JOB #: 52405
6IXTH DEGREE TOWNHOMES
07.14.25

RESPONSE LETTER TO JUNE 6TH PC MEETING:

6IXTH DEGREE TOWNHOMES

SIXTH DEGREE TOWNHOMES

SP-1.1

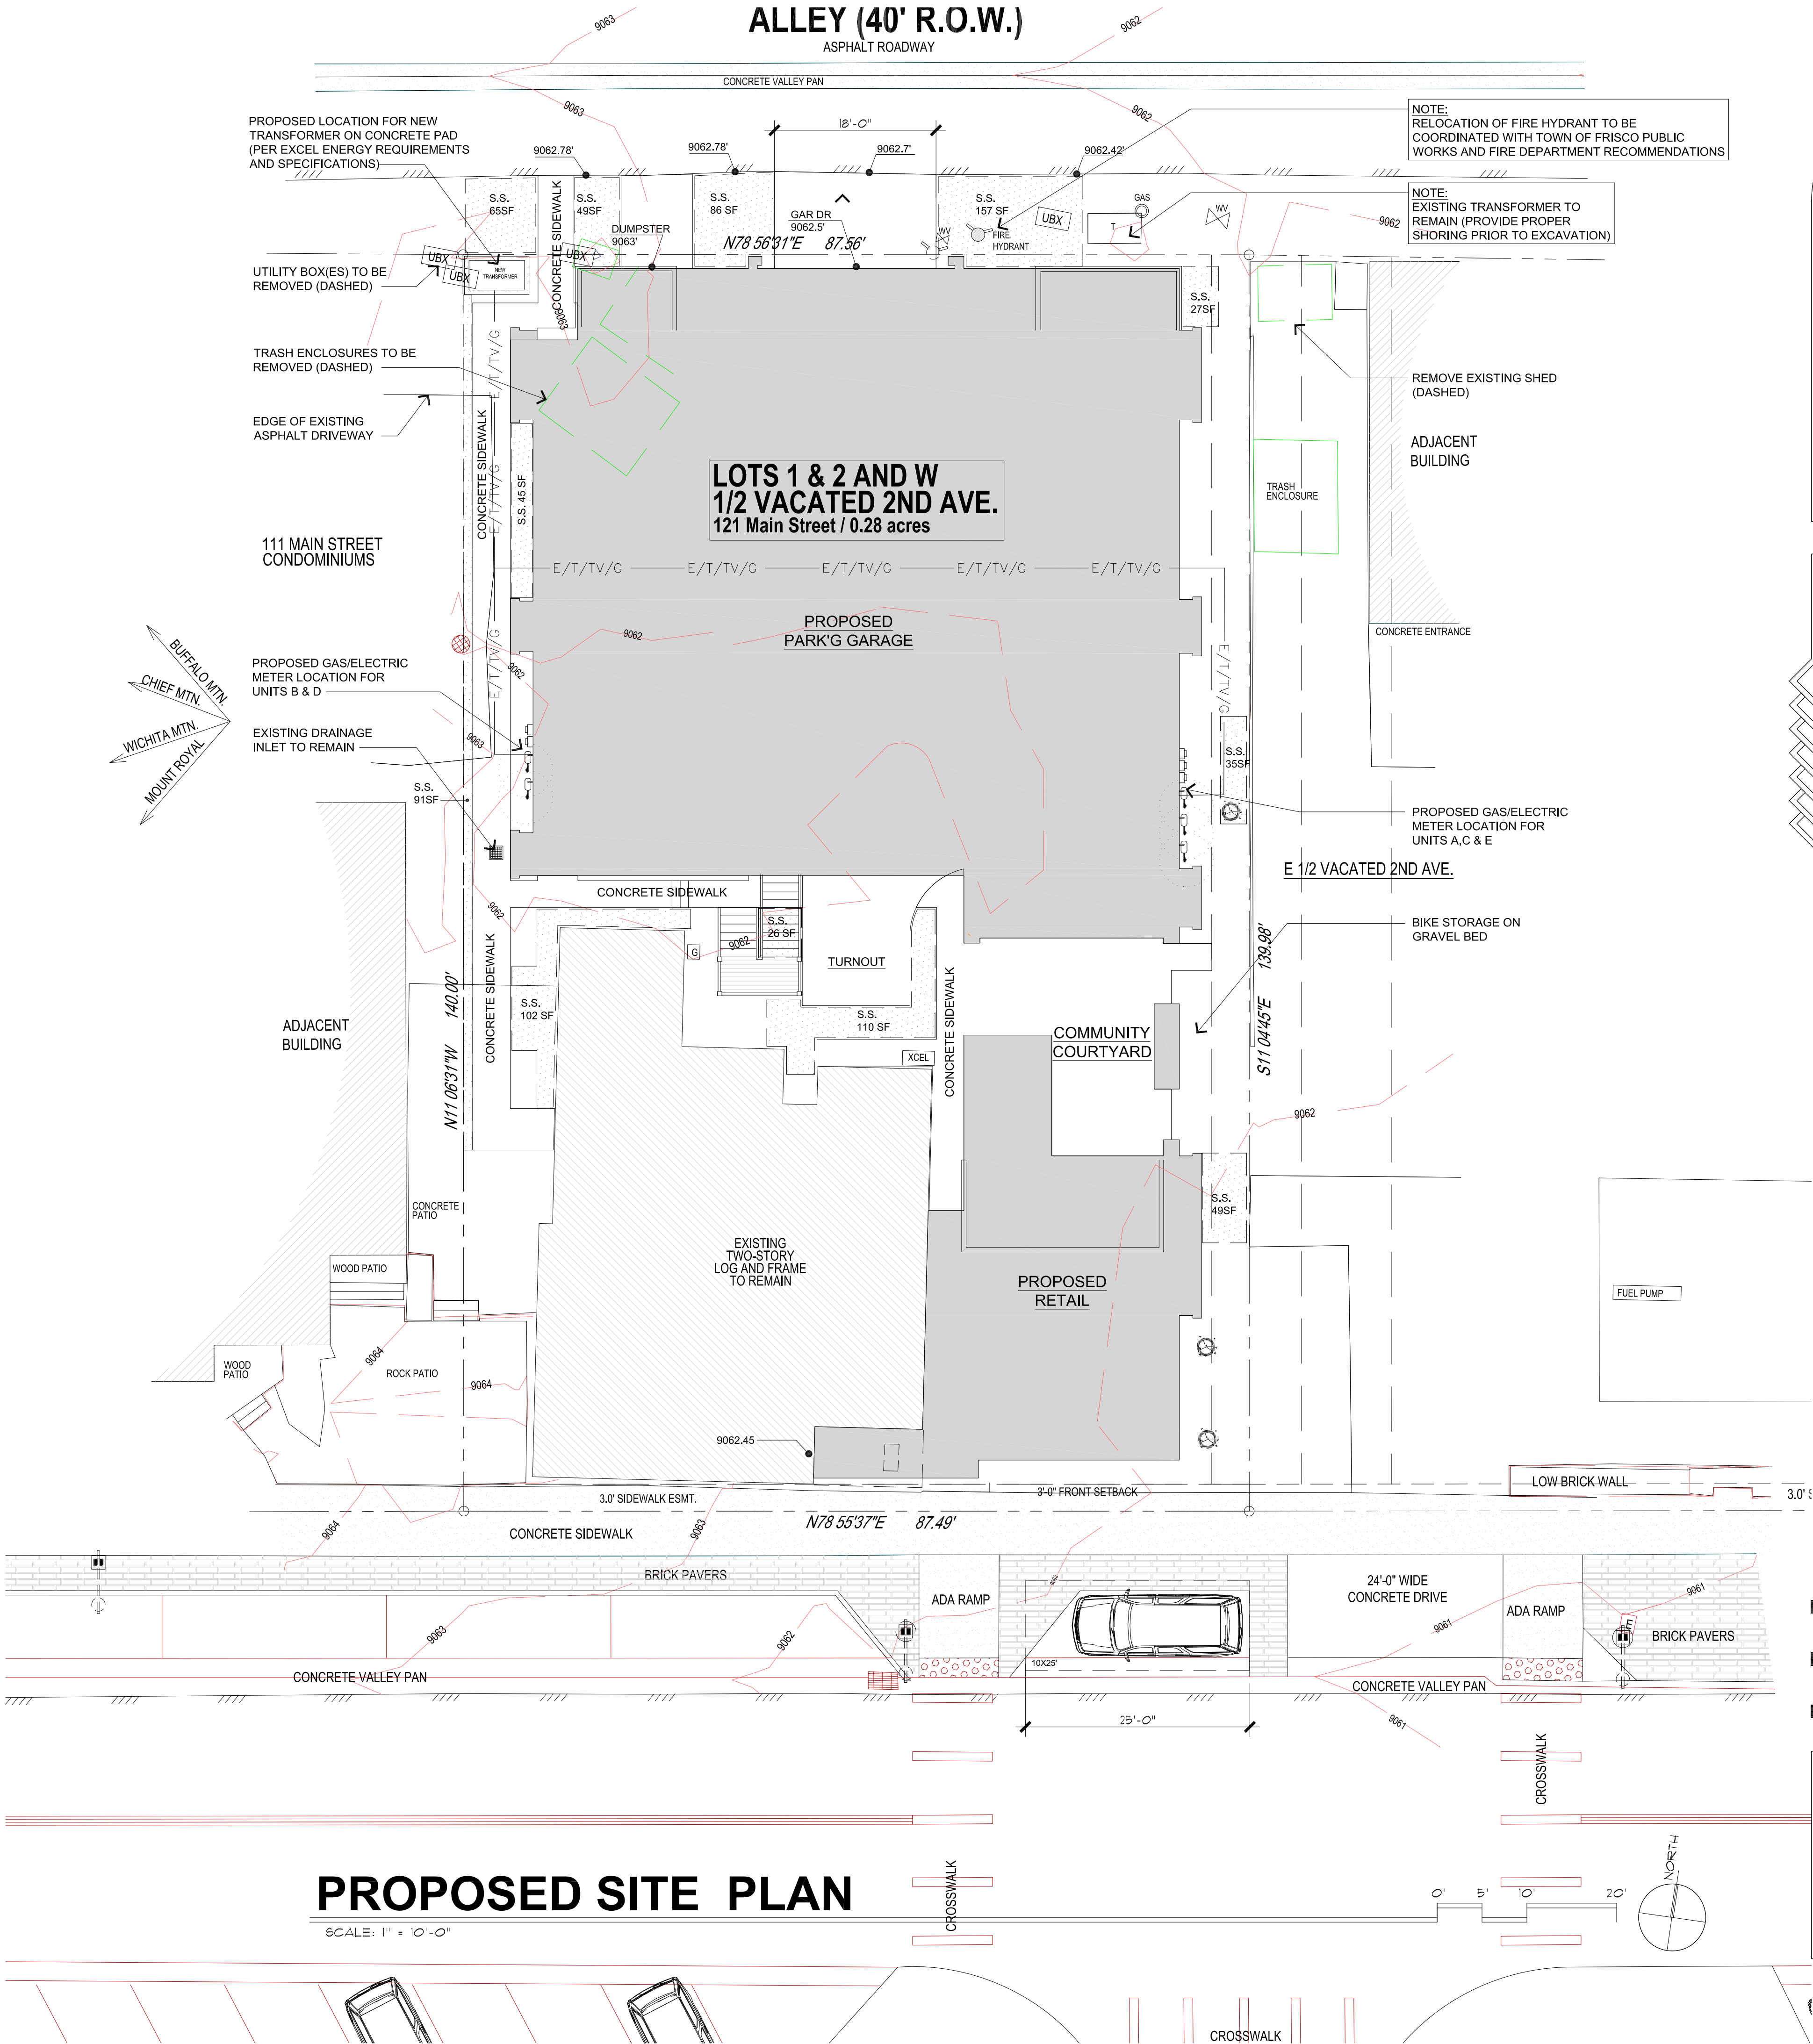
- With the revised parking structure, the snow stack has been updated, and deck calculations have also been provided. (SP1.1)
7. The application will be reviewed for full compliance with §180-6.14, Landscaping and Revegetation standards at the time of final Major Site Plan application.

A-1.3
GROUND LEVEL
PLAN

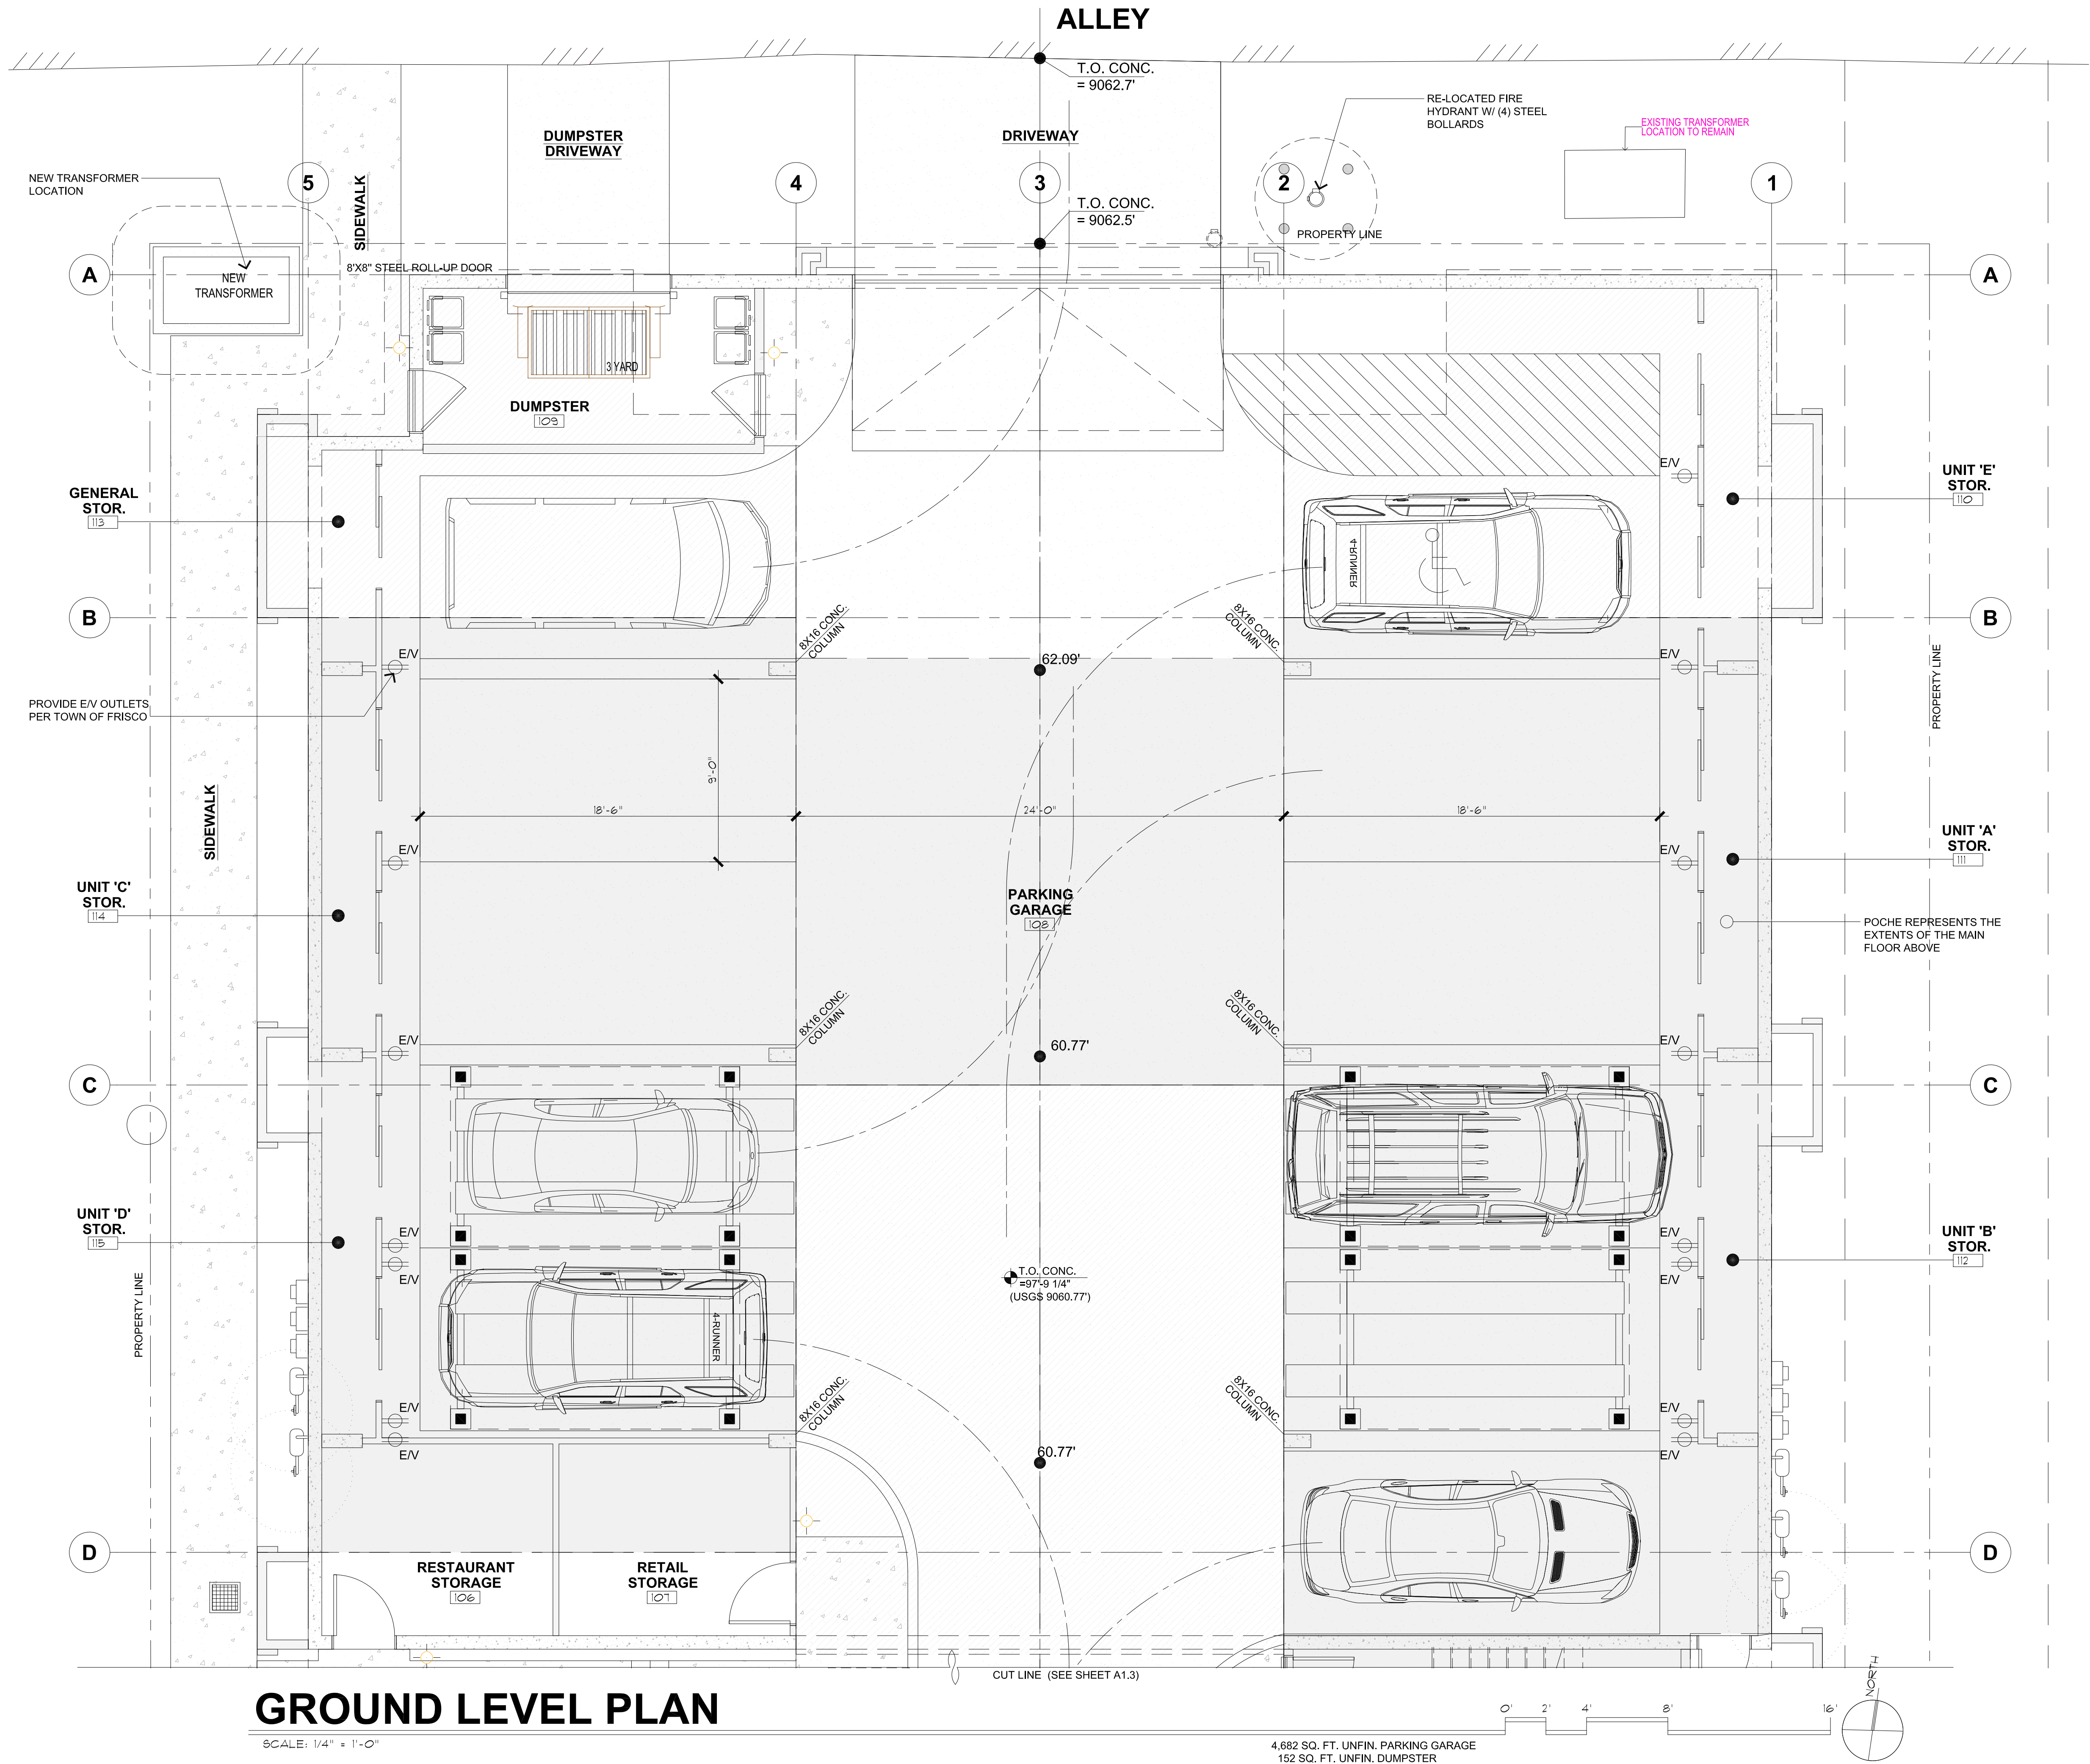
- Bicycle parking has been provided (SP1.3, A1.1 & A1.3) and a community courtyard provided (SP1.1, SP1.3, A1.1 & A1.3)

A-1.4
GROUND LEVEL PLAN

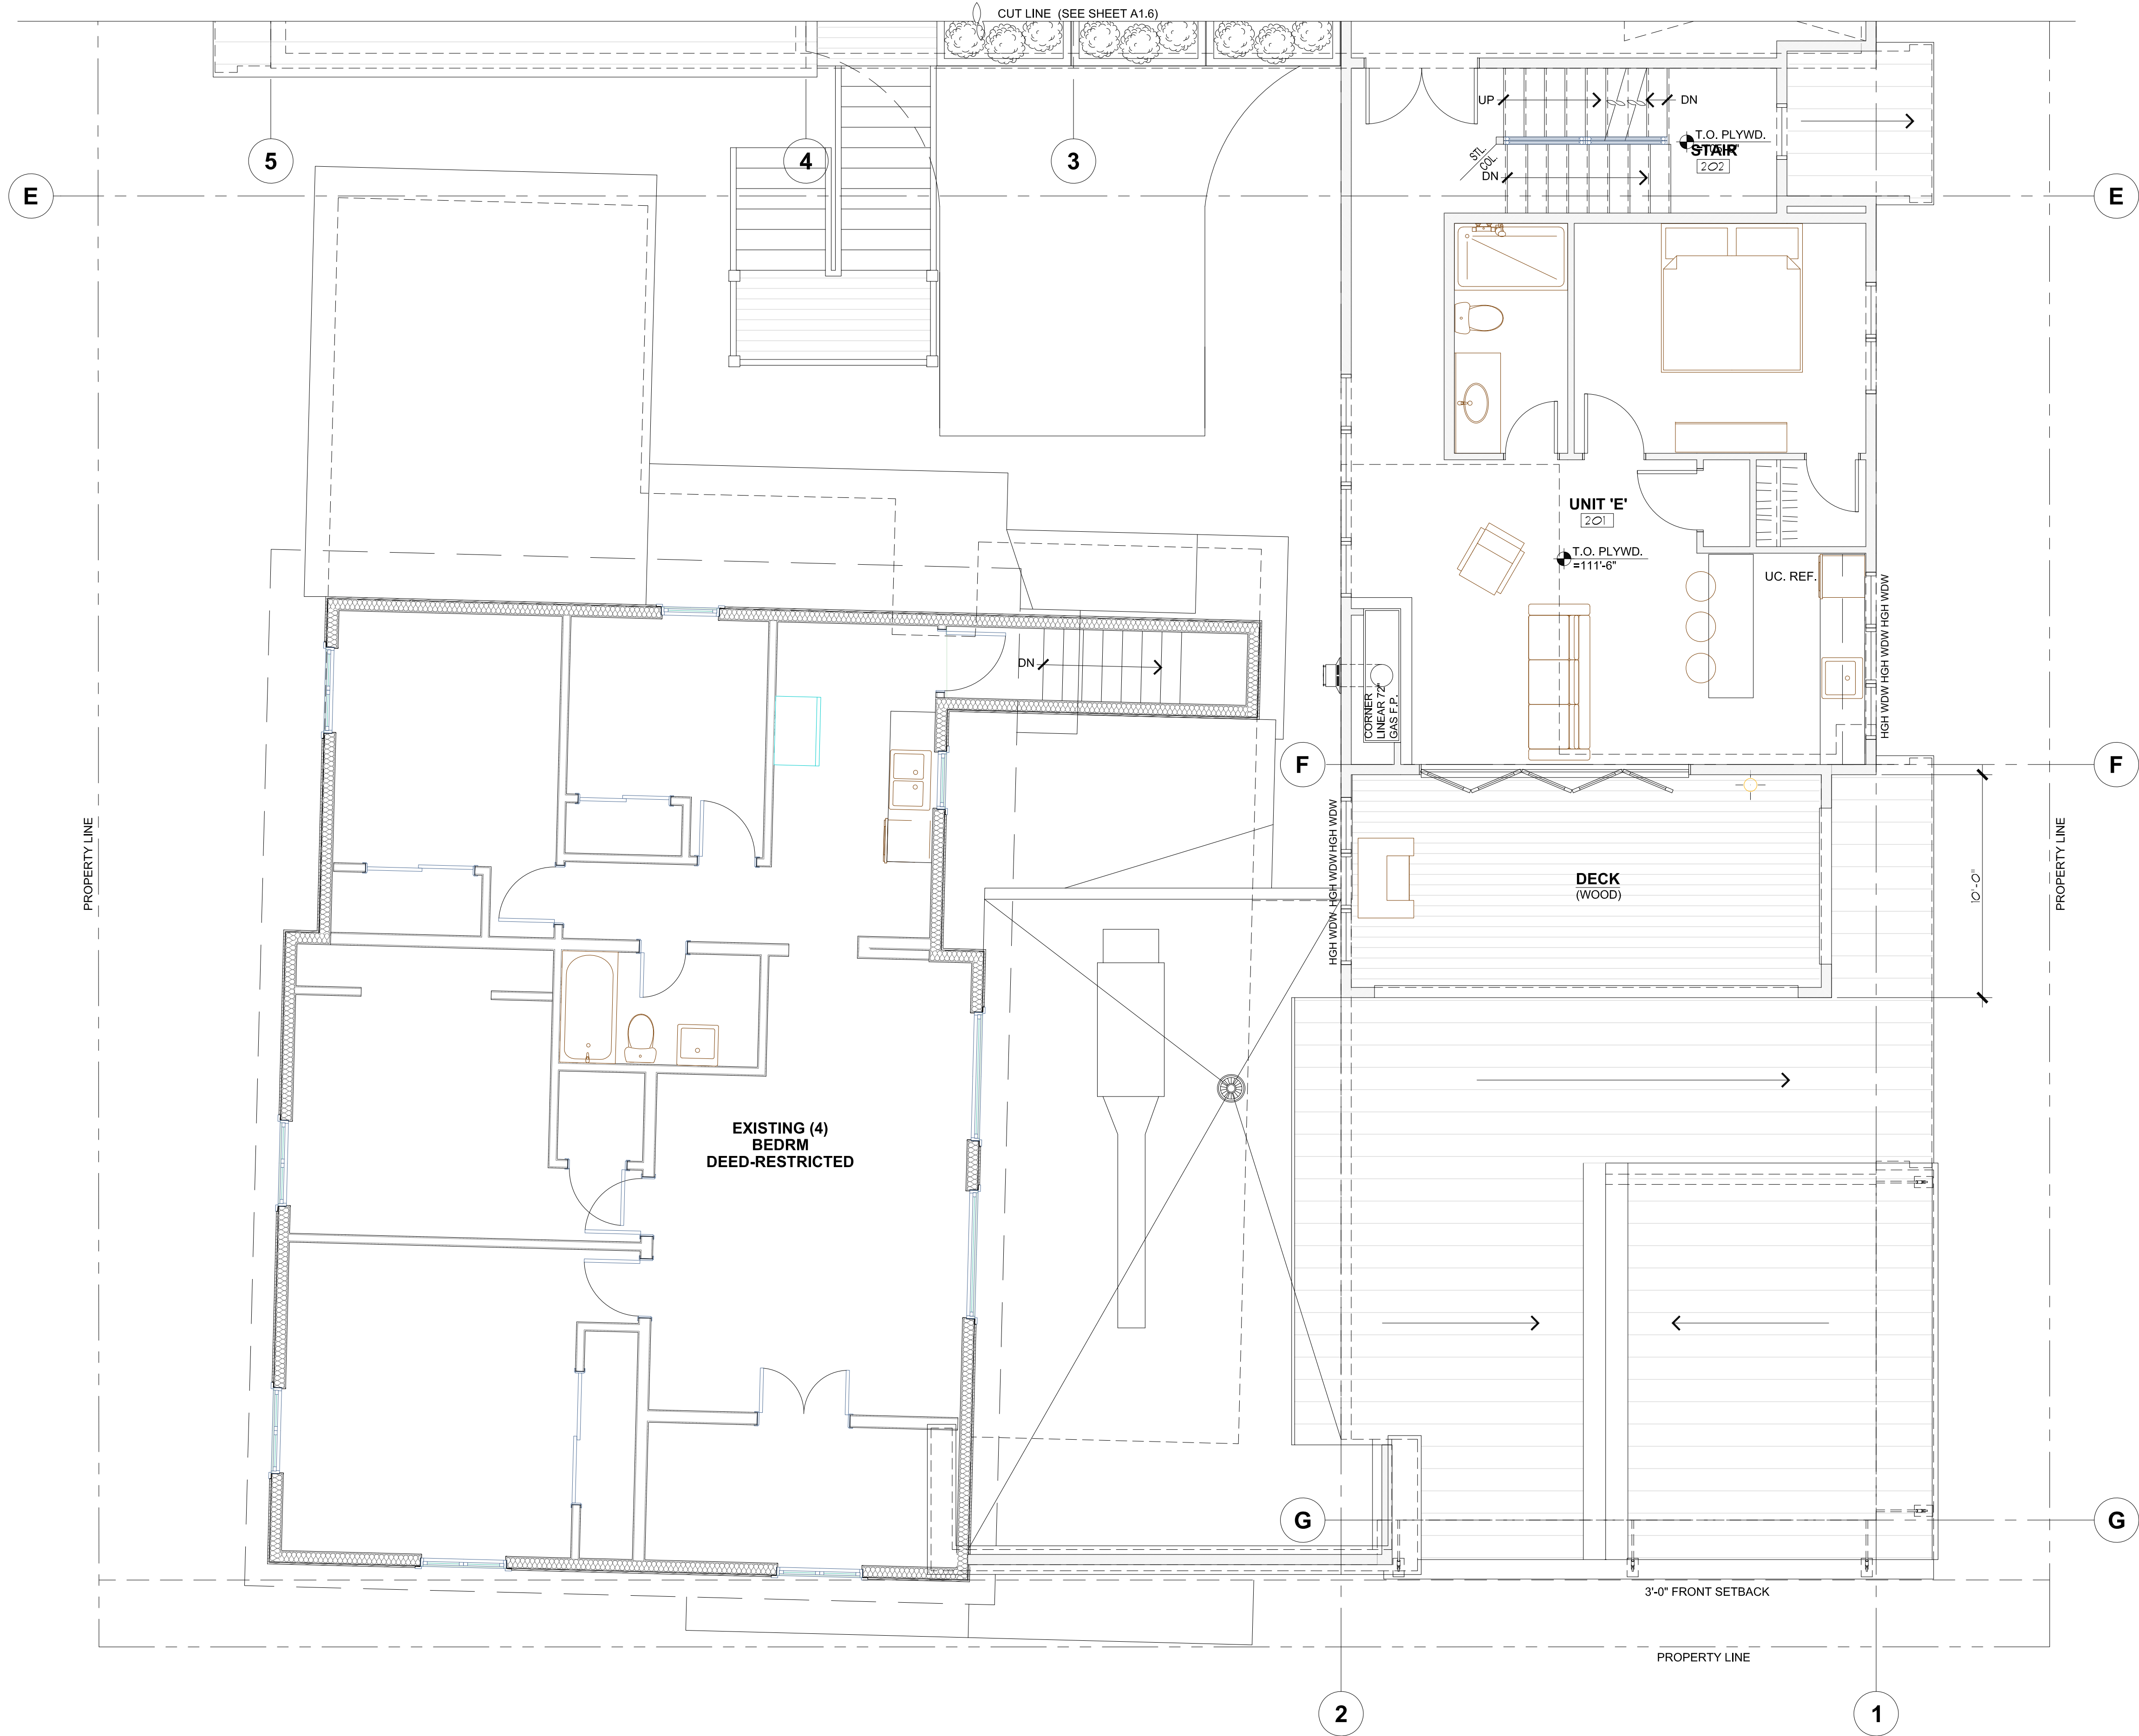
- The parking has been re-designed and is now completely screened from street/alley/side yard (A1.4)
6. The application does not meet the standards for snow storage.
